HEARING REPORT

NOTICE OF REQUIREMENT

50 ORAWAHI ROAD, GLENBROOK

COUNTIES ENERGY LIMITED

Figure 3: Concept site plan - Proposed substation plan

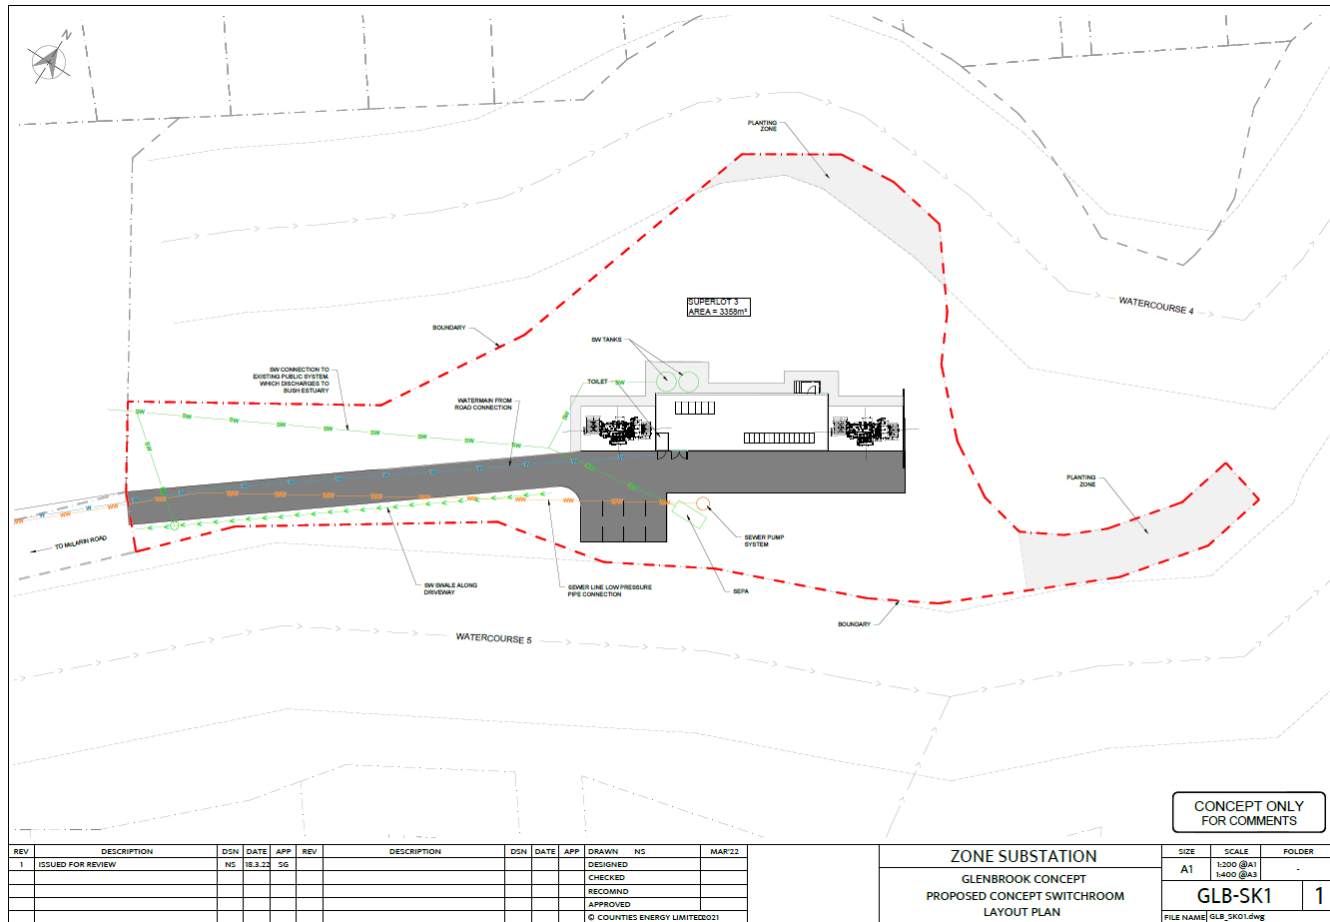
Whilst the substation will be visible when viewed from the street, the substation will be well set back from the street (approximately 100 metres). There will be a concrete wall at the western end of the transformer bay to screen off the transformer. There will be a mixture of low and mid height species as well as specimen trees at the entrance to help anchor the substation. There will be a gate and fences at the end of the shared accessway and areas surrounding the fence will be planted with lower species. There will also be swale planting alongside the accessway.

The existing band of manuka would provide a solid screen. Although its upper walls and roofing might well be visible rising above this planting, it would reduce the apparent scale of the substation and ensure that its appearance is generally compatible of that associated with the surrounding suburban environment.
